Specific Design Plan SDP-2501
Saddle Ridge

REQUEST	STAFF RECOMMENDATION
Umbrella architecture for 19 single-family detached and nine single-family attached home models.	With the conditions recommended herein: • APPROVAL of SDP-2501

STAFF REPORT

SUBJECT: Specific Design Plan SDP-2501
Saddle Ridge

DRAWN BY: D. WILL	
DATE: 08/28/2025	
PROJECT NO. DT10	
11 X 17 SCALE 1/8" = 1'-0"	
24 X 36 SCALE 1/4" = 1'-0"	
HOUSE NAME: COLUMBUS	DRAWING TITLE SIDE AND REAR ELEVATIONS
SHEET No. A.2.3

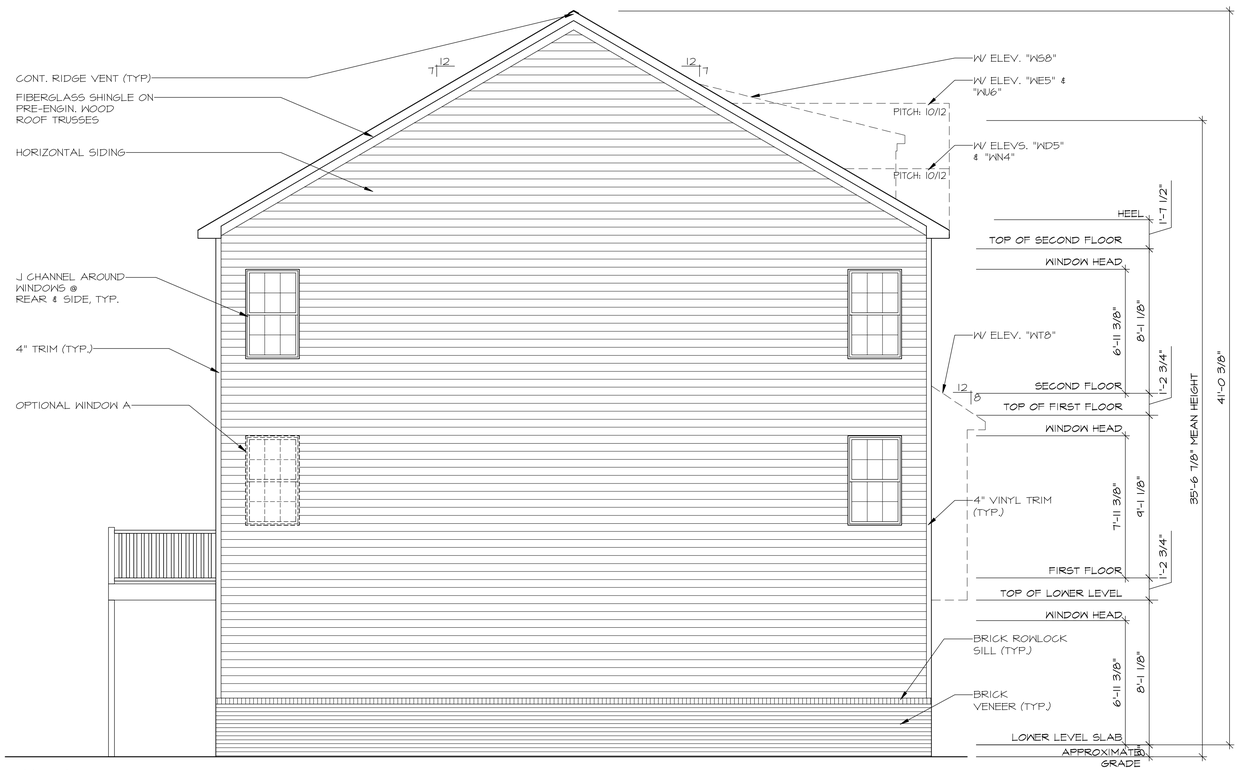
b. Correct Sheet A.2.3 for the Columbus black and white elevations, to identify the left side elevation as high visibility.

SHEET No. A.2.5

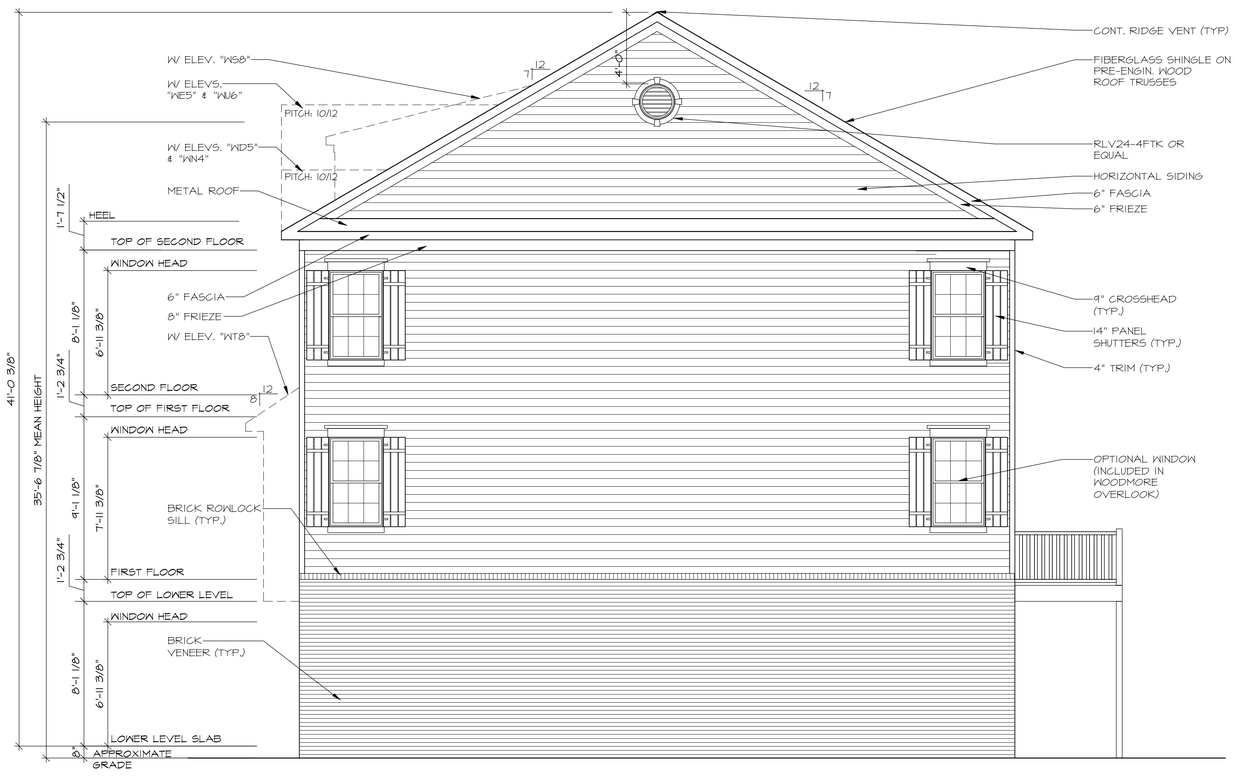
c. Correct Sheet A.2.5 for the Columbus black and white elevations, to identify the right-side elevation as high visibility.
